# ADDENDUM No. 2

FOR  
**GENERAL AVIATION NORTH APRON  
RECONSTRUCTION**  
AT  
**SCHENECTADY COUNTY AIRPORT**

**FAA AIP No. 03-36-0106-066-2023  
County Contract No. RFB-2024-60  
CHA Project No. 079443.000**

**DECEMBER 13, 2024**

Drawing No. **A100**

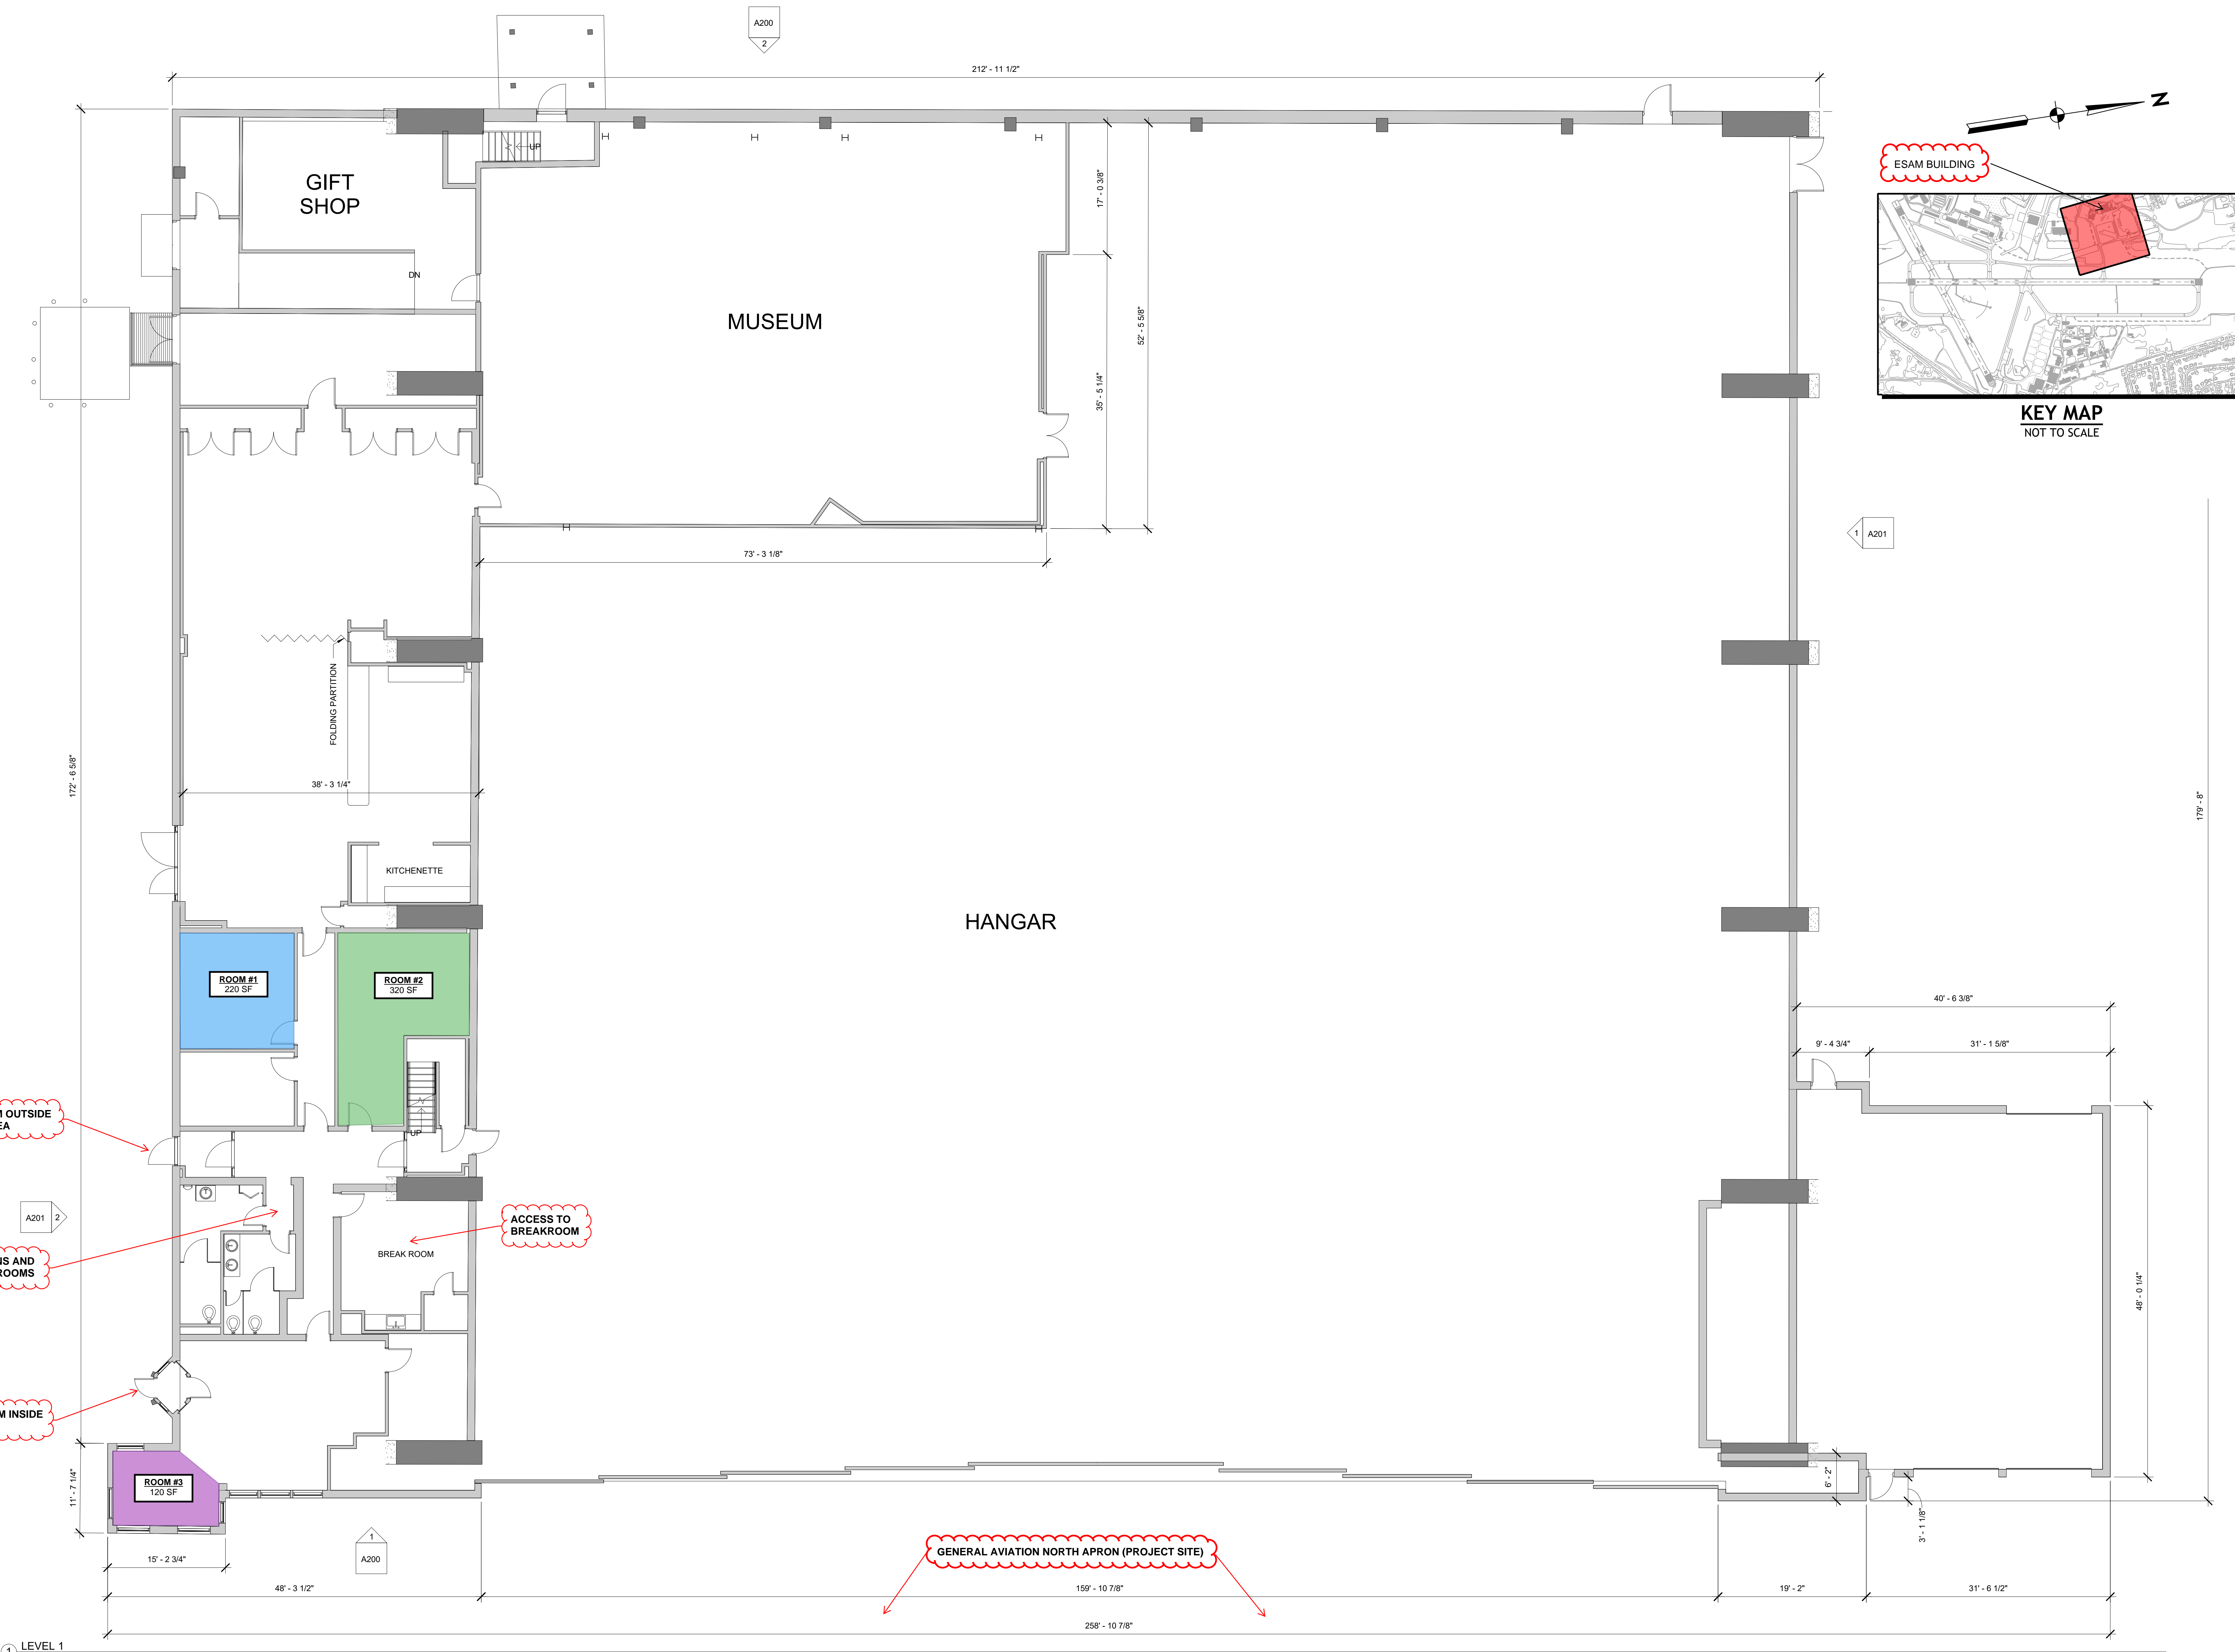
The Contractor is being offered the option to rent office space to be used as their Construction Field Office located within the Empire State Aerosciences Museum building. There are (3) offices being offered are represented on the provided ESAM Floorplan, and have the following specifications:

#### **Room #1 (\$1,500 / Month)**

- 220 LF (approximately)
- Electricity
- Climate Controlled
- No Internet Access
- Non-Furnished
- Carpeted

#### **Room #2 (\$1,500 / Month)**

- 320 LF (approximately)
- Electricity
- Climate Controlled
- No Internet Access
- Non-Furnished
- Carpeted

#### **Room #3 (\$1,250 / Month)**

- 120 LF (approximately)
- Electricity
- Climate Controlled
- No Internet Access
- Non-Furnished
- Non-Carpeted
